1241 W. Calle De La Plaza  
Sahuarita, Az. 85629  
March 8, 2006  
Phone (520) 625 - 3327

**Docket Nos. W-01583A-04-0178, et al.**

W-01583A-04-0178  
W-01583A-05-0326  
W-01583A-05-0340

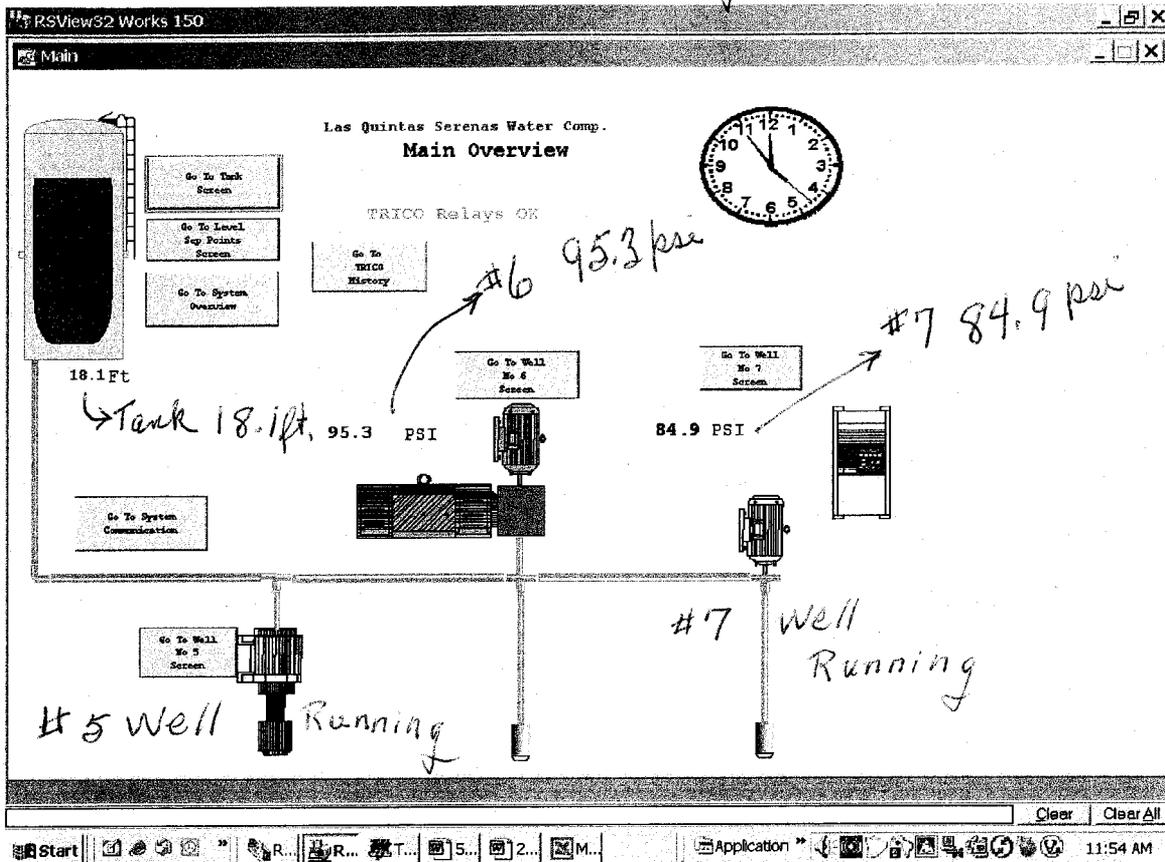
are. The highest I have gotten so far is 100 psi on the gauge at #6 well with #5 and #7 operating and the pressure at the office for #6 showing 95.3 psi with the water level of the big tank at about 18 feet. I have not calibrated the pressure gauges in the field and I understand the pressures shown on the charts in the office come from transducers at each well. Attached are copies of the displays in the office. The originals are in color, but for my 12 to 17 copies they will be black and white, so Dorothy Hains, Mark Taylor, Jason Gellman, and Judge Rodda will each get one of the colored ones and all the rest will be black and white.

#5 & #7 wells running

Field measurements March 6, 2006 by John Kay:

#5 Well running	11:10 AM @ 225 gpm	65 psi	13,468.5 hr	63,724,000 gal
#6 not running	11:25 AM	100 psi	3,974.8 hr	59,911,800 gal
		not the engine	2,731.6 hr	
#7 Well running	11:40 AM	84 psi	23,890.4 hr	42,135,800 gal
